TSIB 22-13 Rev B		July 9th, 2024
TO:	Affected Operators	
TITLE:	Torque value change to splined joint on the upper steering shaft.	
APPLICABILITY:	New Flyer Xcelsior buses equipped with double tilt steering columns & upper steering shaft New Flyer part number 532703.

This TSIB will provide an updated recommendation for torque of hardware used to secure the splined joint in on the upper steering where it joins to the steering column.

Figure 1: Location to Torque on Upper Steering Shaft

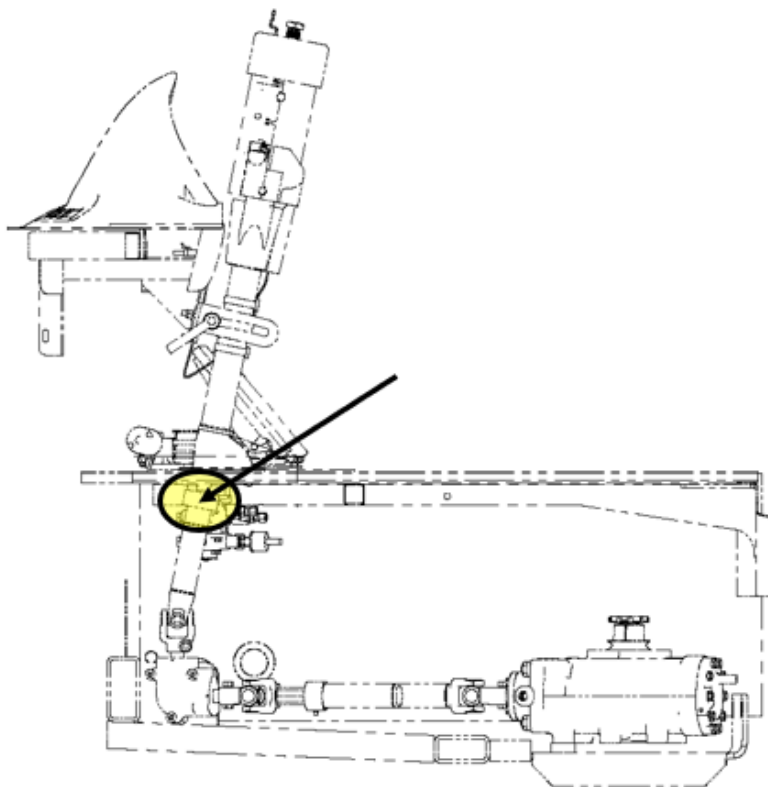
For customers operating New Flyer Xcelsior buses equipped with double tilt steering columns, it is New Flyer's recommendation that, at the next maintenance interval, the torque in the location depicted in the diagram be increased from 50 ft-lb to 70 ft-lb $\pm$ 4 ft-lb.
